**Trash Pad Location and Sizing**

Subject: ETC Commercial Trash Enclosure

## Trash Enclosure Height

Subject: ETC - Lot 1/2 trash enclosure

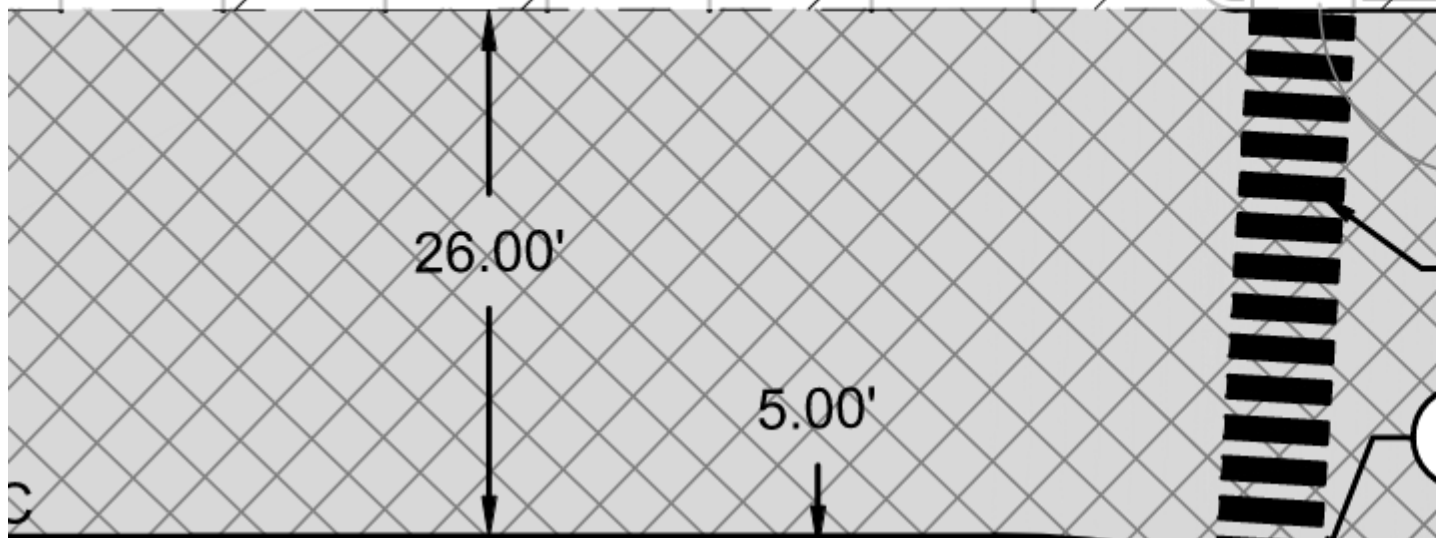
We are working through the submittal for the trash enclosure for the commercial areas.  
Can you confirm this will work for you?  
These are all roll offs. No compactor.

Would you be able to coordinate with the trash hauler to confirm that the proposed location and enclosure size meet their service needs?

We need to respond to this Mark comment:

Provide email confirmation from the waste hauler that the proposed enclosure size and location meets the provider's service needs.

Trash Enclosure must be 14 ft wide and have 40 ft space in front

Most enclosures are at minimum 14ft wide and have a 40ft apron leading up to the enclosure. Let me know if you have any other questions.

9 EAST ELEVATION  
SCALE: 1/4" = 1'-0"

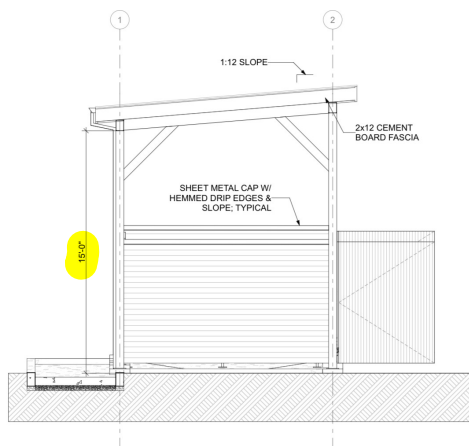
Thanks, Clint. I assume we meet this clearance height?

Can you confirm the vertical clearance on a trash enclosure that has 6yd containers?

Do one of you know the vertical clearance (to bottom of beam above the opening)?

Trash Enclosure must be 15 ft tall, confirmed our design is at least 15 ft tall.

We're 15ft on the back side so the front has more clearance than required

The supervisor says 15 ft.
